Planning Board Report PORTLAND, MAINE

104 Grant Street, CBL 048 0008001
Level III Site Plan/Subdivision, IZ Conditional Use
PL-000960-2020
Watson Renewal Grant, LLC., Applicant

104 Grant Street, LLC. submitted a Level III Site Plan application for a residential project on Grant Street between Deering Avenue and Mellen Street in the Parkside neighborhood. The project includes Level III Site Plan, Subdivision, and IZ Conditional Use applications which are reviewed and approved through the Planning Board. The proposal is for a single four-story building with 23 affordable apartments. The required parking is provided in a combination of twelve (12) on-site and eight (8) off-site. All of the required 3 affordable units will be provided on-site. The project is located in the R-6 zone and is not within any historic district.

FILE: 1093.3_CIVIL
JN: 1093.3
SCALE: AS NOTED
DESIGNED BY: SJL
DRAWN BY: KRB
CHECKED BY: WHSDRAWING NO.
C-10

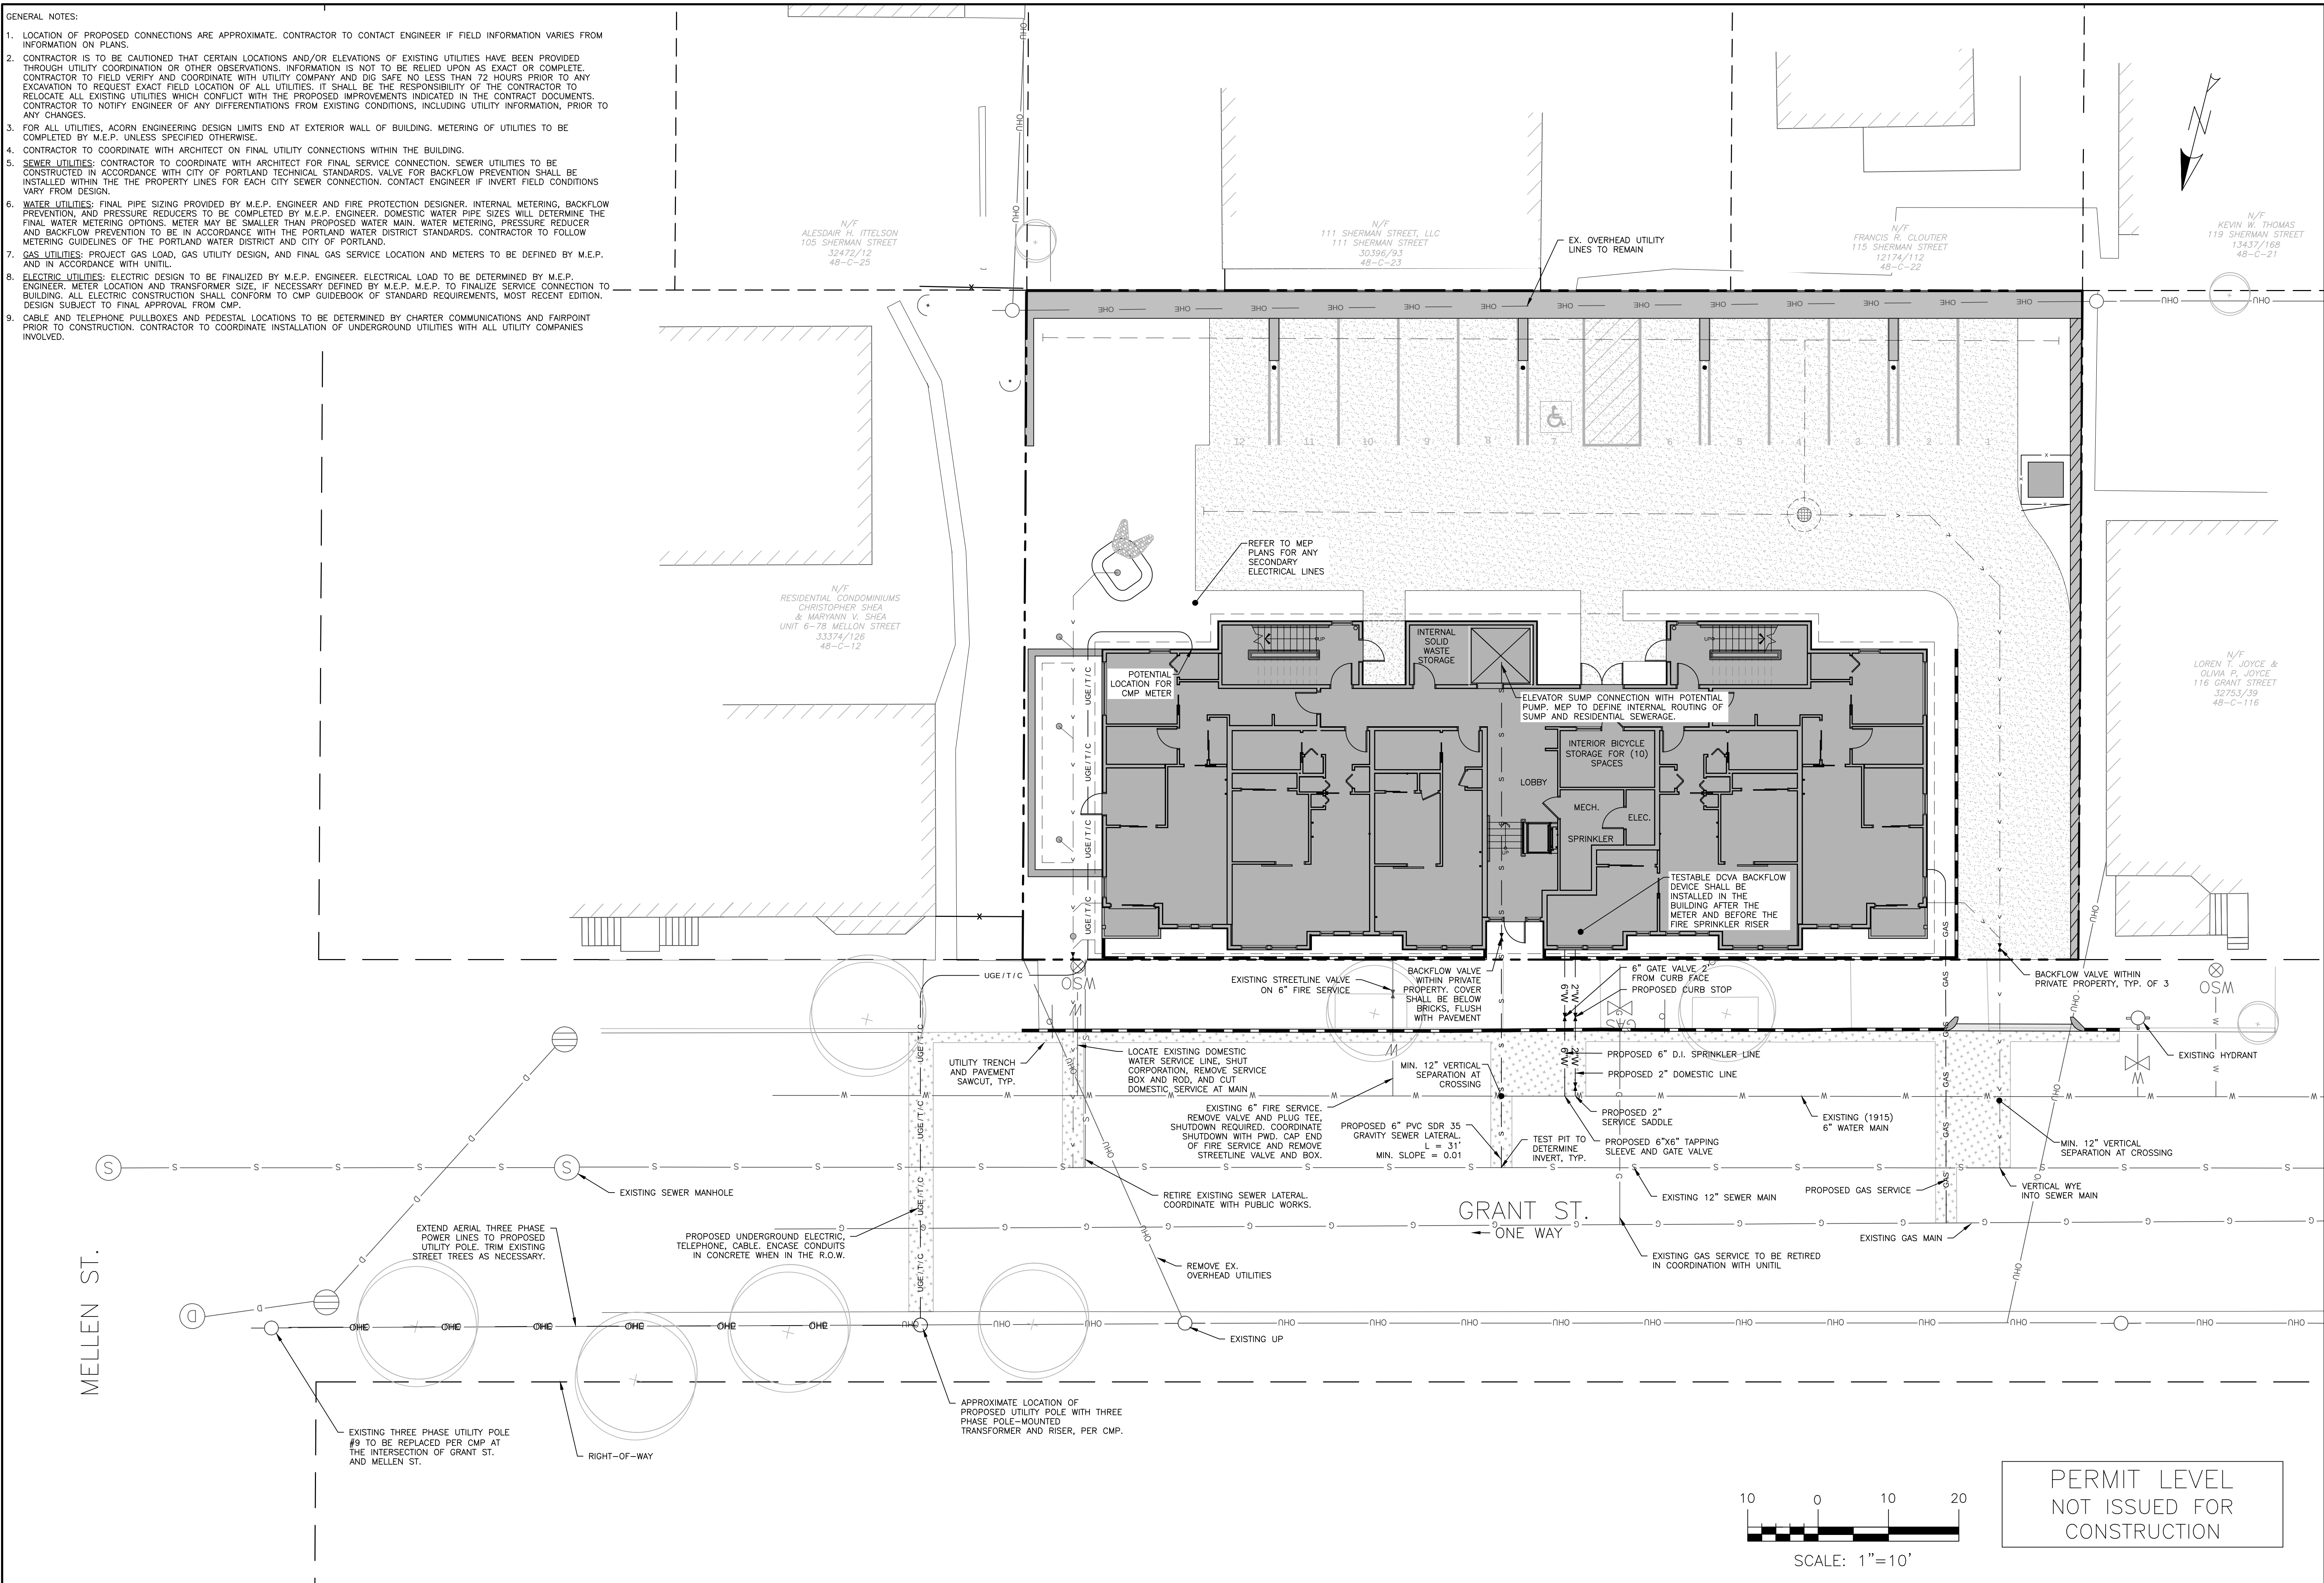
- The on-site surface parking is accessed via a single two-way driveway to the side of the building. The applicant requests a waiver for the driveway width of 16' (20' required). Mike Tremblay, Senior Engineer at DPW, requested a striped pedestrian path be added to the drive for safe access from the sidewalk to the rear of the property.
5-foot walkway [should] be closer to the building so that pedestrians would not need to cross the driveway after exiting the back of the building. If there is a reason for placing it where they did, then that's fine, but . . . I think it makes more sense adjacent to the building."

- The parking layout requires two waivers – parking stall dimensions and drive aisle. Mike Tremblay, DPW, reviewed the layout and supports the waiver requests (Attachment 1):
Included in the Technical Manual section 1.14 waiver should also include drive aisle width. Only 20.5 +/- feet is provided for drive aisle width. Turning movement diagrams have been provided, and they show that vehicles are able to enter and exit each space. DPW does not oppose the section 1.14 waiver.

- The City Arborist requests the street tree well detail to be changed to a flush grate consistent with the street scape, in addition, the number and spacing may need to be adjusted due to conflicts with utilities:

If there is on-street parking the tree planter wells should be flush to avoid contact with opening car doors etc. This is in keeping with other trees nearby.

- Included in the Technical Manual section 1.14 waiver should also include drive aisle width. Only 20.5 +/- feet is provided for drive aisle width. The applicant should show that a vehicle can turn into and out of Space 12 given the drive aisle and slightly substandard parking space widths.

The only comment I have is minor and need not be addressed prior to the PB hearing, but I imagined the 5-foot walkway to be closer to the building so that pedestrians would not need to cross the driveway after exiting the back of the building. If there is a reason for placing it where they did, then that's fine, but if it's all the same to them I think it makes more sense adjacent to the building.

If there is on-street parking the tree planter wells should be flush to avoid contact with opening car doors etc. This is in keeping with other trees nearby. The number of trees & spacing is dependent on the underground utilities, ideally we try to line them up to be approximately between the car spaces vs where the door open or in front of building accessways.

- Included in the Technical Manual section 1.14 waiver should also include drive aisle width. Only 20.5 +/- feet is provided for drive aisle width. Turning movement diagrams have been provided, and they show that vehicles are able to enter and exit each space. DPW does not oppose the section 1.14 waiver.

PARKING SPACE DIMENSIONS

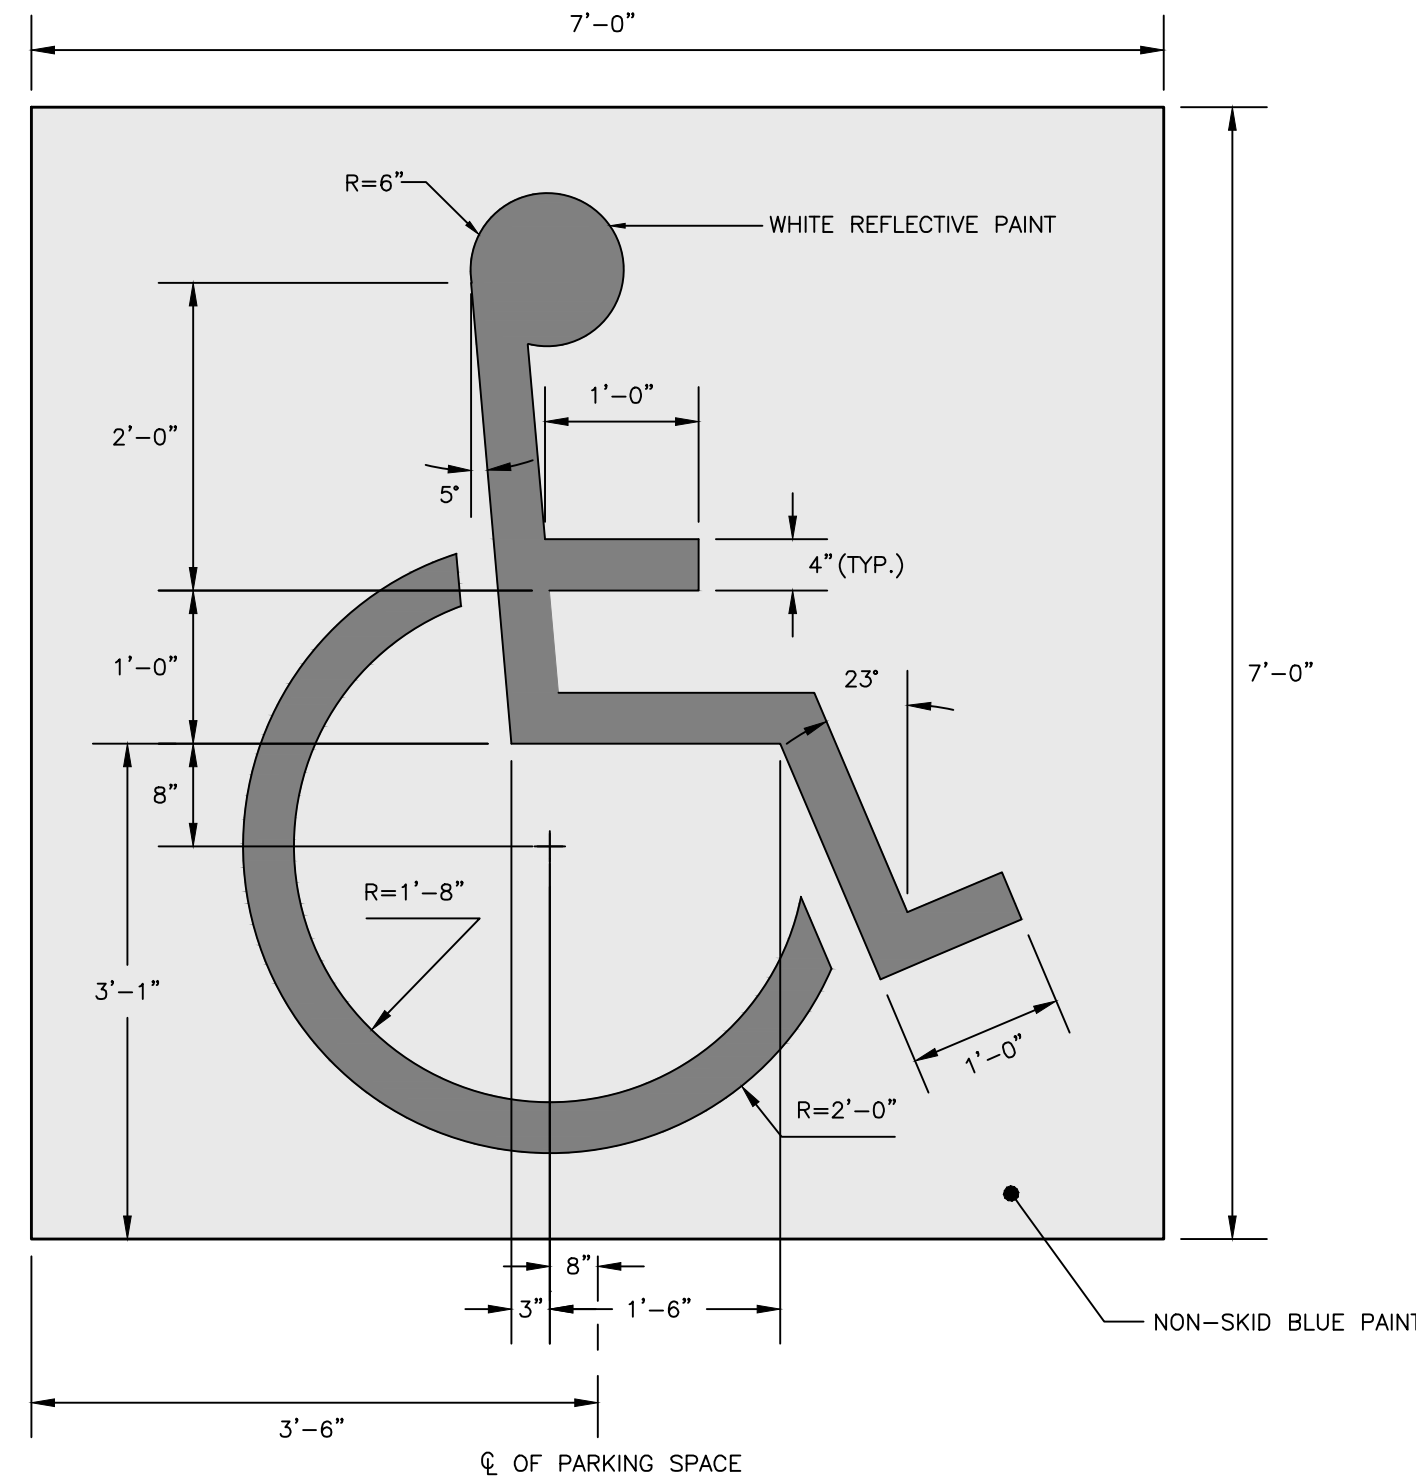
1. The Planning Board [**finds/does not find**], based upon the consulting civil engineer's review (*Attachment 1*), that extraordinary conditions exist or undue hardship may result from strict compliance with the Technical Manual Figure I-27. Parking Stall Dimensions. The Planning Board [**waives/does not waive**] the Technical Manual Standard to allow parking dimensions of 8.5' x 18.'
